Joint Comments Regarding Cinder Bed Road Bikeway

AUDUBON NATURALIST SOCIETY • SIERRA CLUB GREAT FALLS GROUP • AUDUBON SOCIETY OF NORTHERN VIRGINIA • FRIENDS OF ACCOTINK CREEK • VIRGINIA NATIVE PLANT SOCIETY, POTOWMACK CHAPTER • FAITH ALLIANCE FOR CLIMATE SOLUTIONS

July 11, 2022

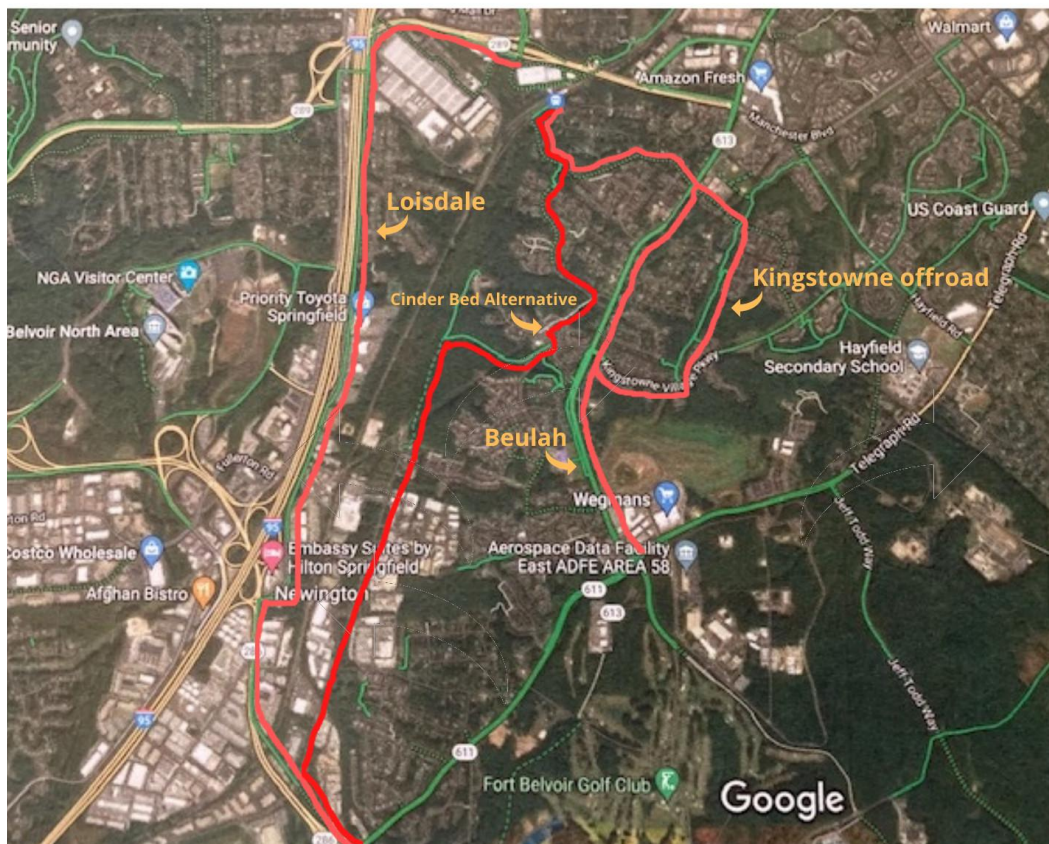
Several safe alternatives to Segment 6 exist today

FCDOT's analysis of alternatives was inadequate. Real, workable alternatives to Segment 6 exist today, shown on the Fairfax County Bike Map⁵, yet no studies were undertaken to determine the level and patterns of use of the existing Metro access trails documented below, nor to assess the need for yet another north/south route. Improving existing alternatives could require coordination with VDOT, but would provide safe transportation for bikers and protect rare habitats at a fraction of the cost.

Four cycling and pedestrian options that exist today as well as a bus route, are described below.

The base map above is courtesy of Google's "Biking" map which indicates cycling routes in green. Routes marked in red are currently available alternatives described in detail below.
